IMPORTANT SAFETY RECALL
NHTSA Recall# 17V-832

No: B18001

Re: Truck Body Vertical Leg Support Inspection/Repair

Figure 1

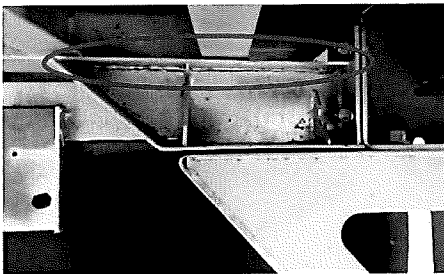
Figure 1 is an example of a completed weld. This weld may be on either side of the center flange.

On affected units the horizontal full length weld at the joint of the center flange and top plate will not be present.

Before weld application, remove the galvanizing or paint coating in the area that is to be welded. Weld the joint according to the welds in Figure 2. After the weld is complete a re-application of a "cold" galvanizing paint or protective coating must be applied to the area.
